**Year 1 Monitoring Report**

**MOCKINGBIRD SITE**

NCDMS Project # 100021 (Contract # 7185)

RE: Mockingbird Site: Year 1 Monitoring Report (NCDMS ID 100021)

**Figure 2**

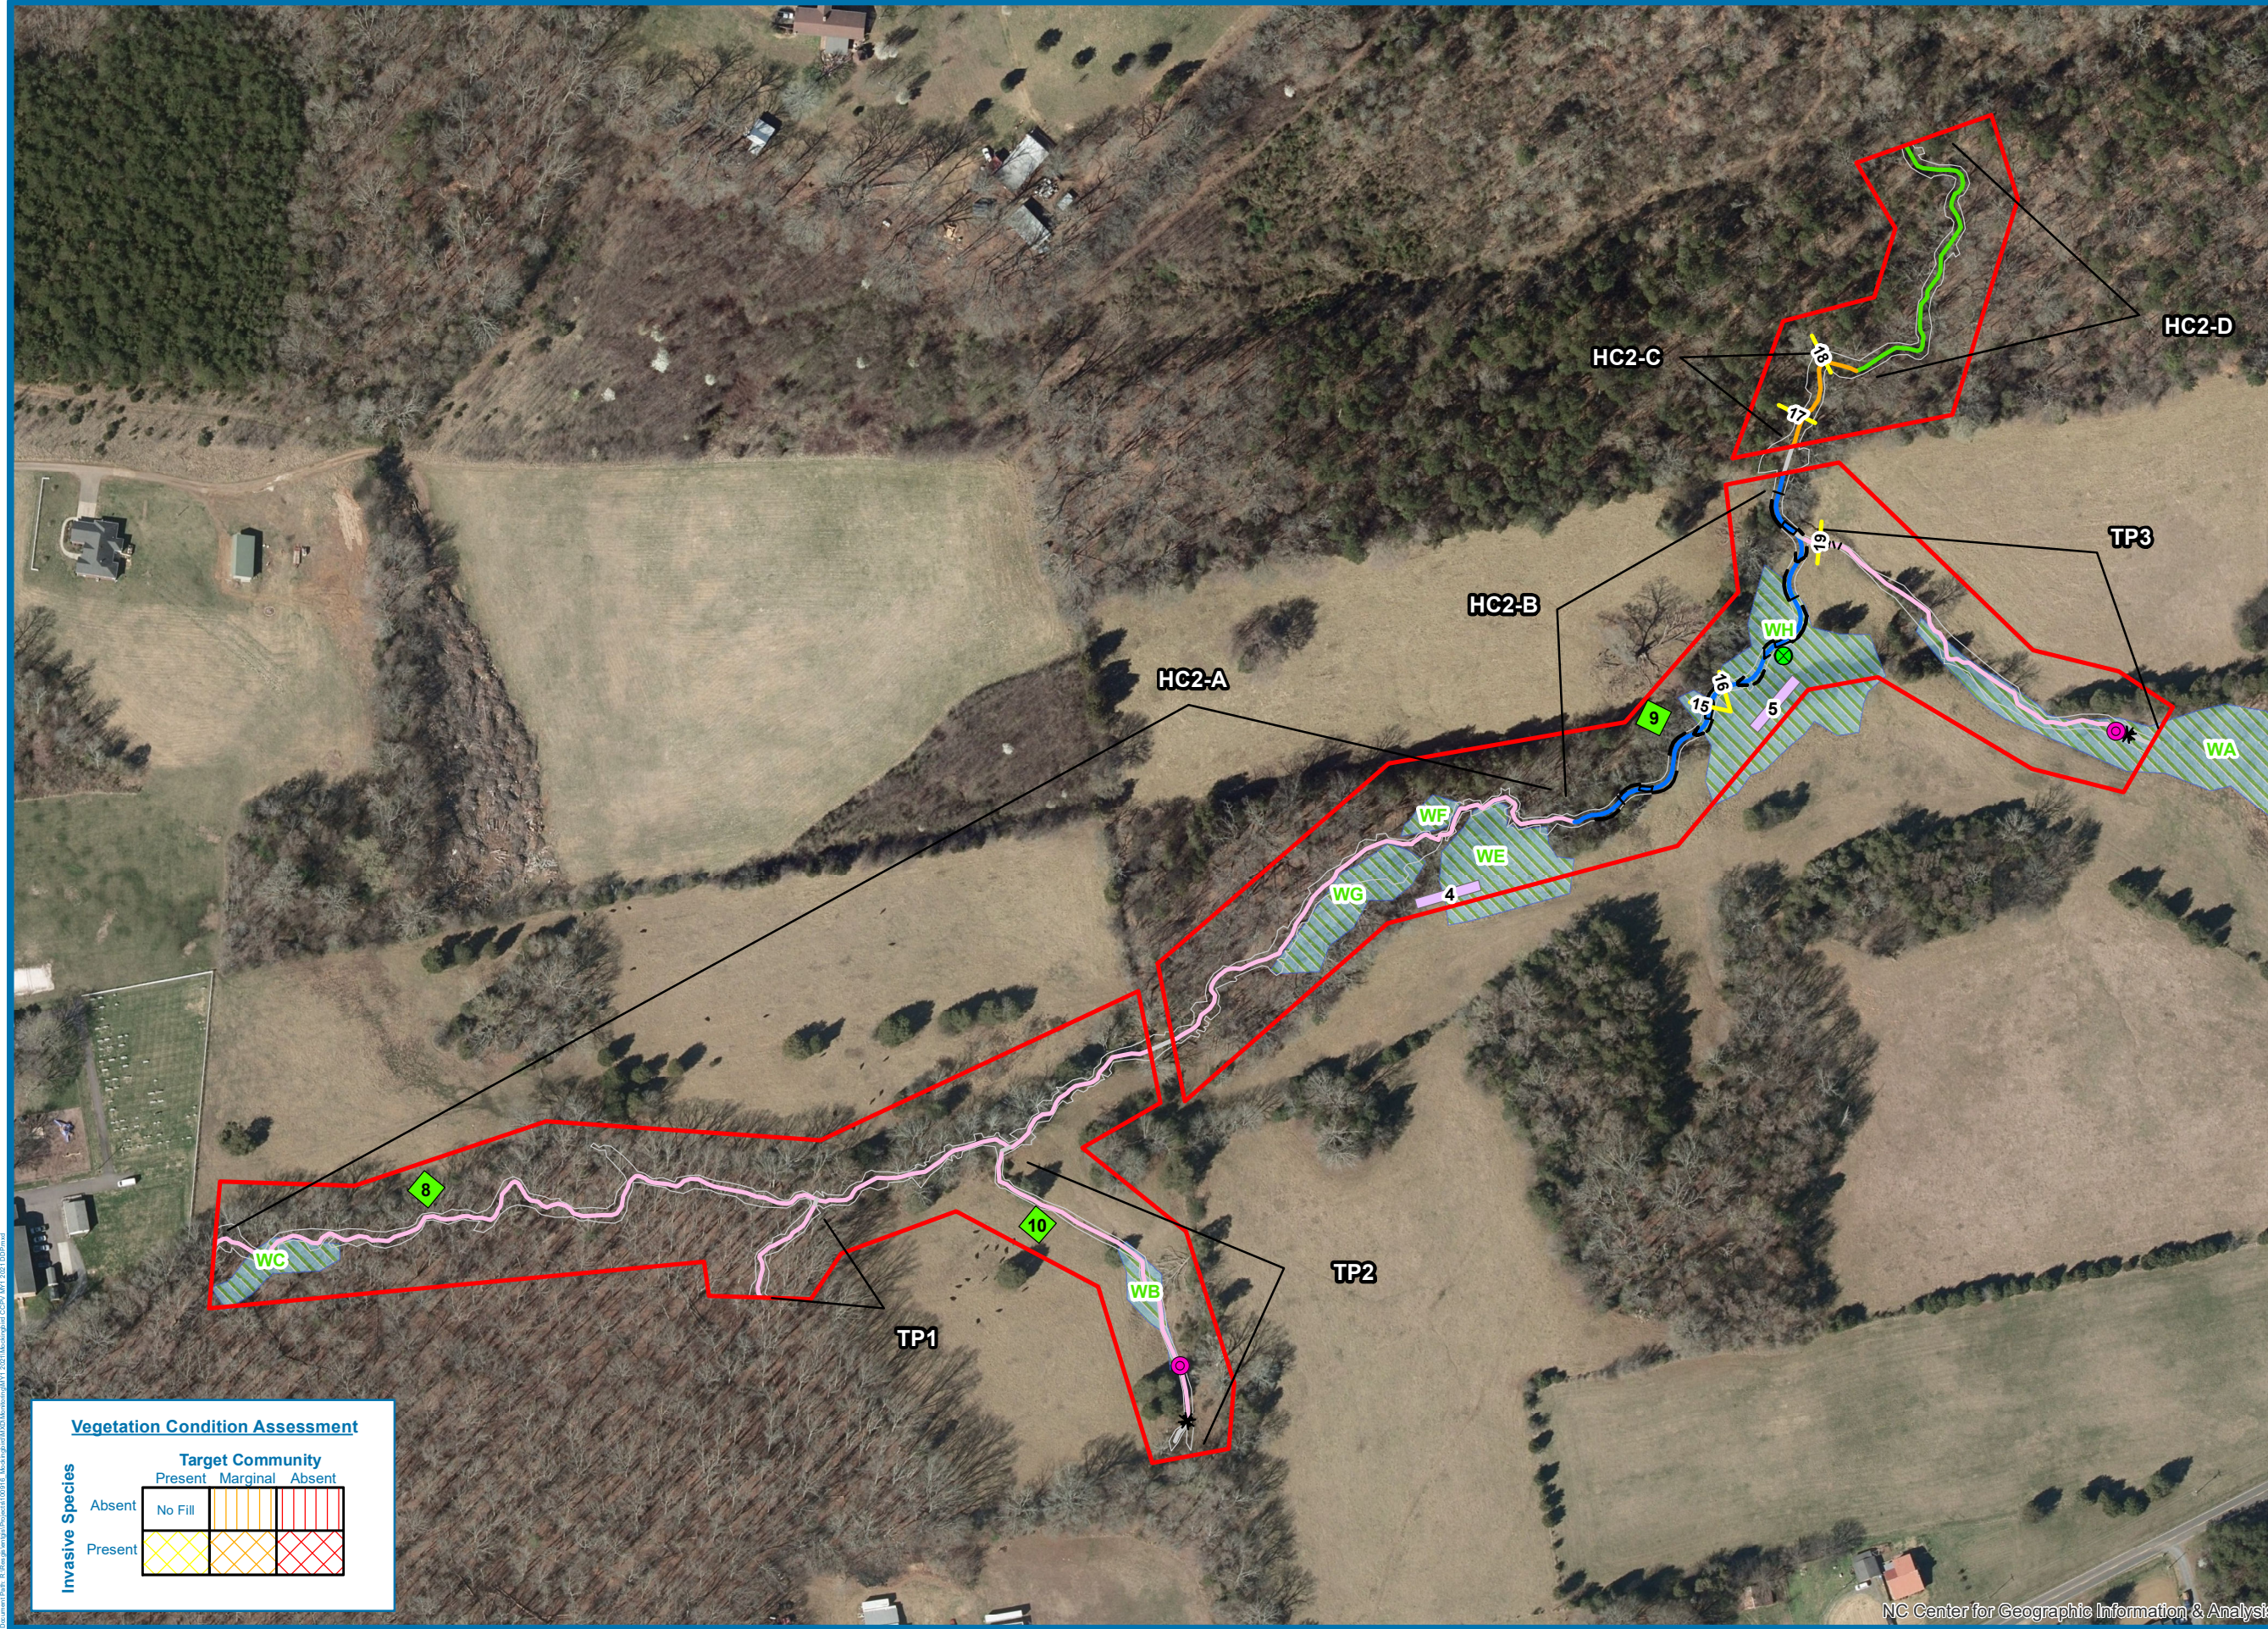
Please map the location of the minor hand grading / repair on HC1  
[Now included on the MY1 CCPV Figure](#)
